Planning Commission Date: May 23, 2007 Item No. 2.

MILPITAS PLANNING COMMISSION AGENDA REPORT

TITLE:	**USE PERMIT NO. UP2007-5 and "S" ZONE APPROVAL NO. SA2007-5**
Proposal:	A request for a new sign program, which includes installation of a new monument sign at the corner of McCarthy Boulevard and Sumac Drive for the SanDisk corporate campus.
Location:	601 McCarthy Boulevard (APN: 086-02-039) and 900 to 1100 Sumac Drive (APN: 086-01-037, 039, 040)
RECOMMENDATION:	**Approval with conditions**
Applicant:	SanDisk Corporation, 601 McCarthy Blvd., Milpitas, CA 95035
Property Owner:	RREEF, 3303 Octavius Drive #102, Santa Clara, CA 95054
Previous Action(s):	"S" Zone approval and amendments
Environmental Info:	Exempt from CEQA pursuant to Section 15311 (Accessory Structures)
General Plan Designation:	Industrial Park
Present Zoning:	Industrial Park with "S" Combing District (MP-S)
Existing Land Use:	R&D Buildings
Agenda Sent To:	Applicant/Owner
Attachments:	Plans
PJ No.	2484

SIGN (J) EXISTING

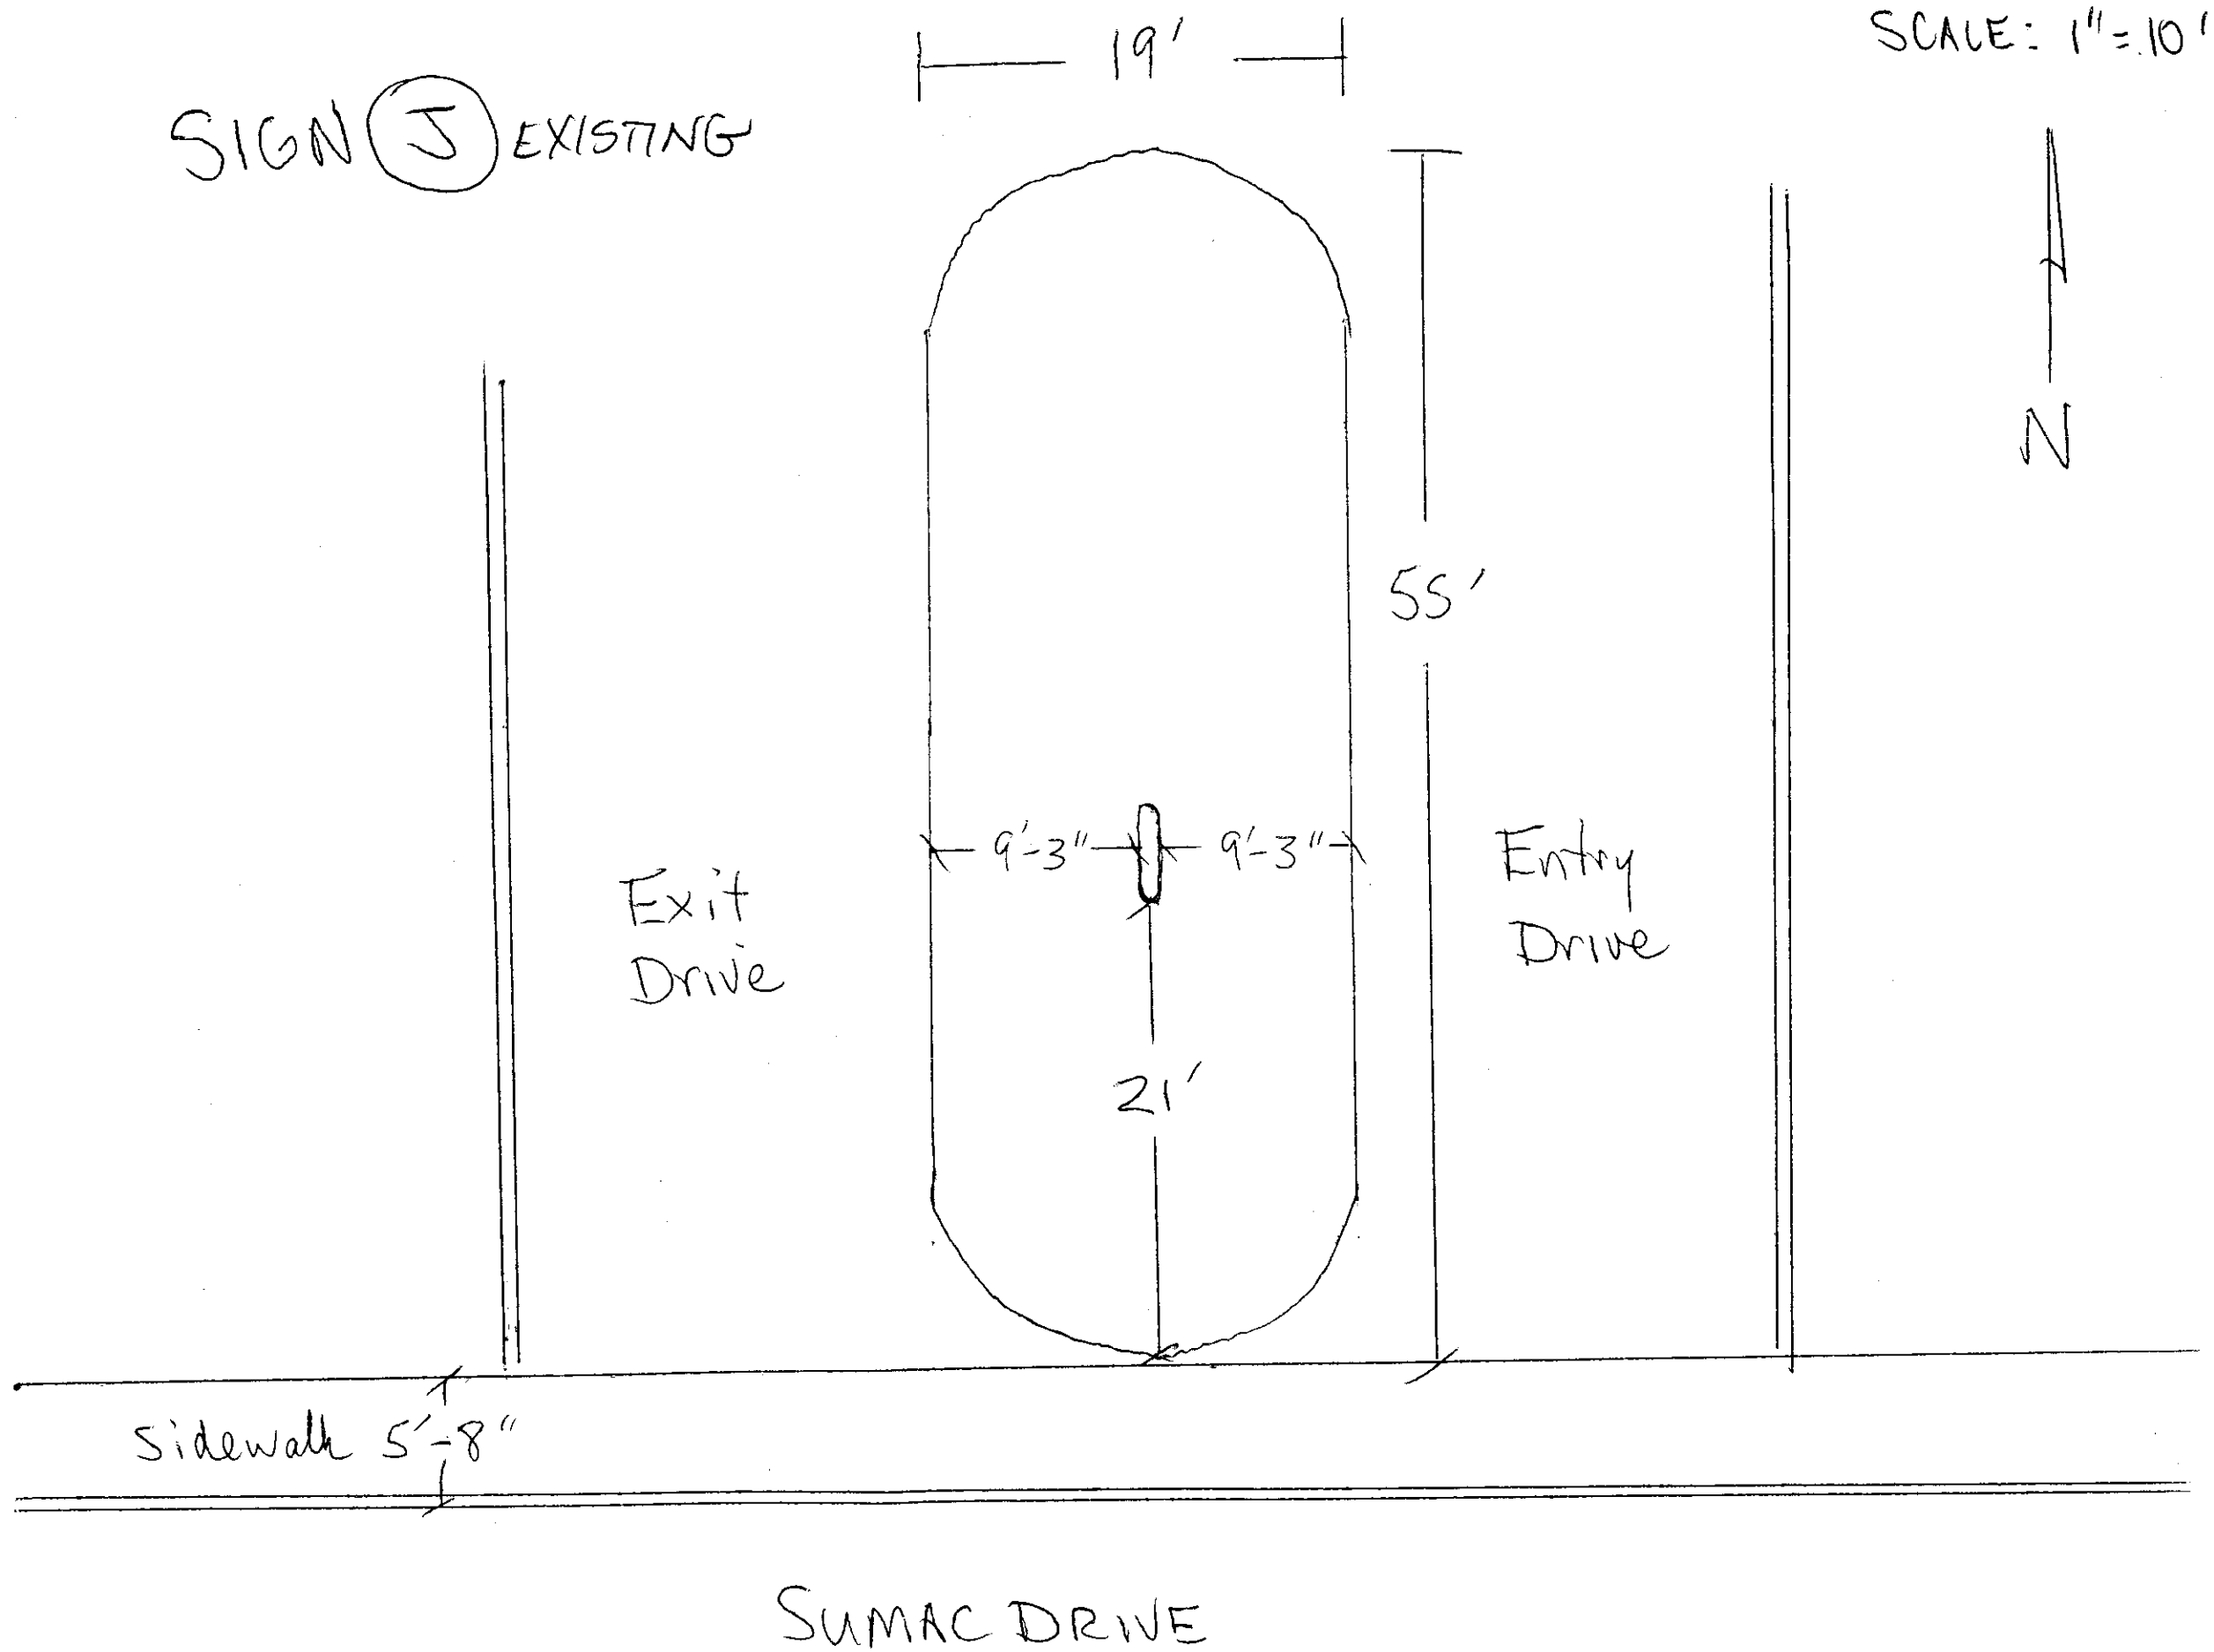
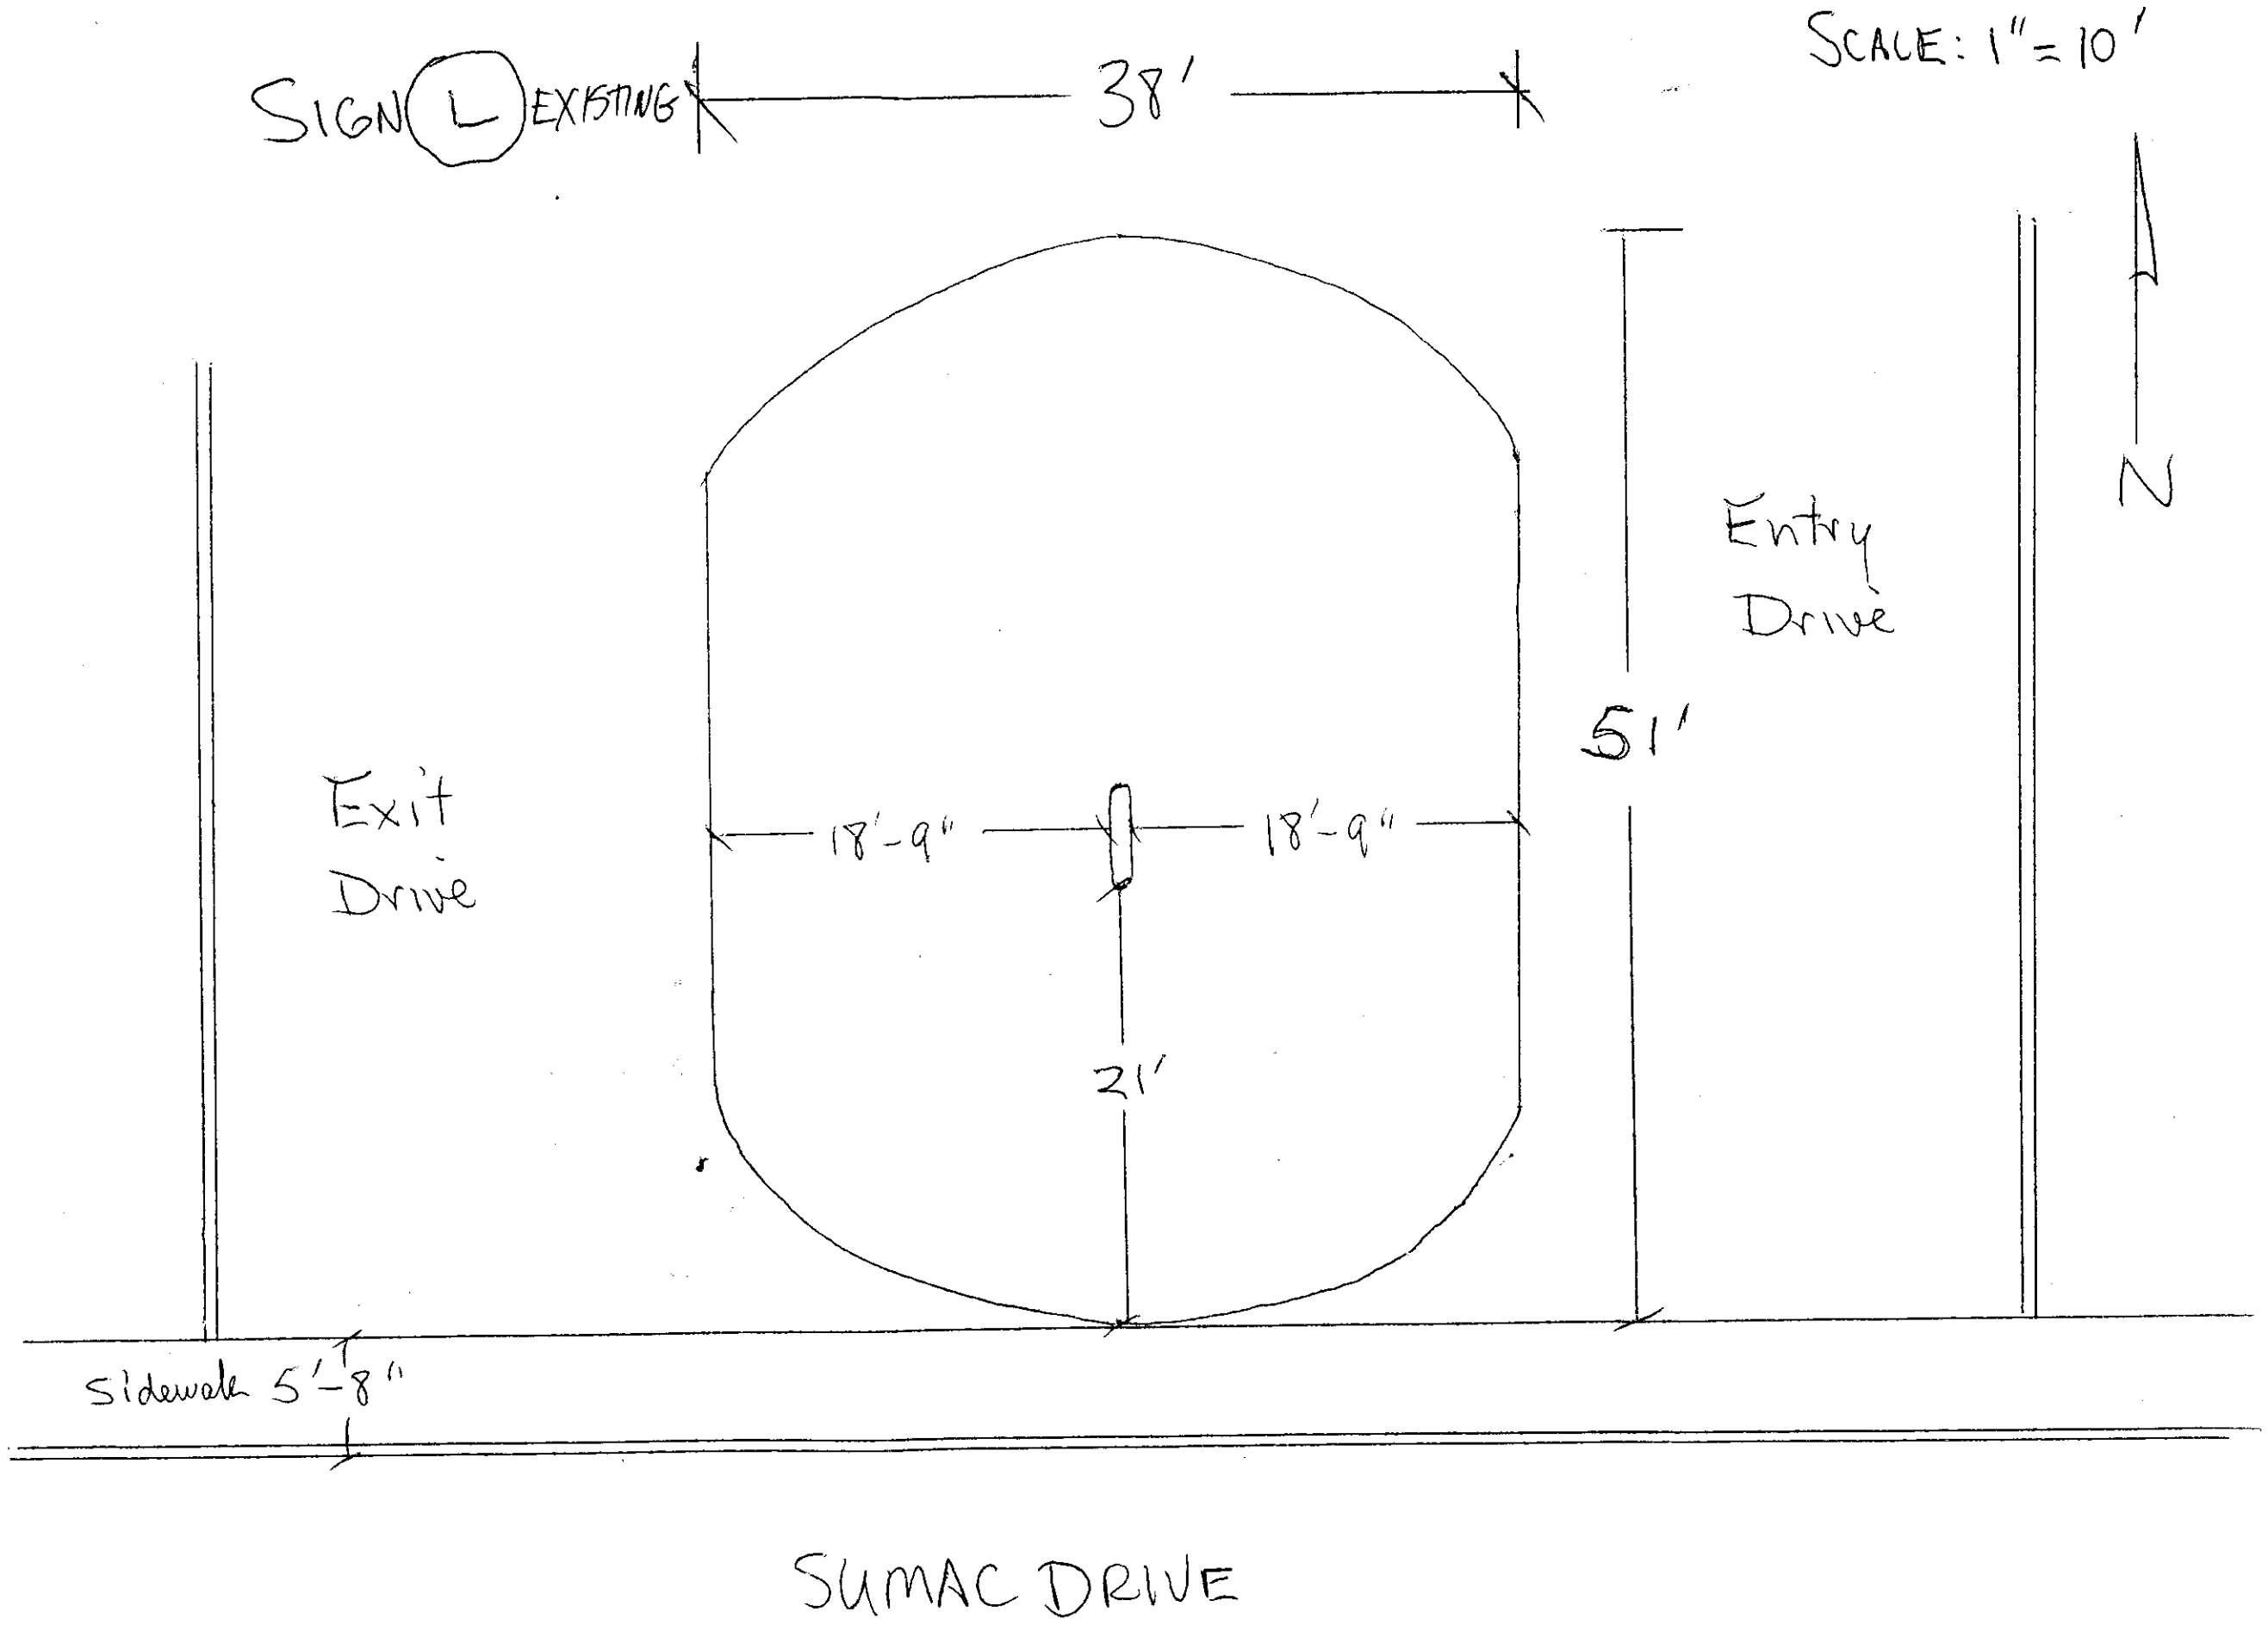
Staff is concerned with the visibility of the lettering on the driveway directional signs. As proposed, the driveway directional signs are located in a landscaped median. During a site visit staff noticed that the address and building numbers were obscured due to the existing height of the shrubs and/or have missing landscaping. *Staff recommends* a condition that the applicant modifies the driveway medians with suitable landscaping that is attractive and enables the lettering on driveway directional signs to be clearly visible and legible

3. The applicant shall modify the driveway medians with suitable landscaping that is attractive and enables the lettering on driveway directional signs to be clearly visible and legible. (P)
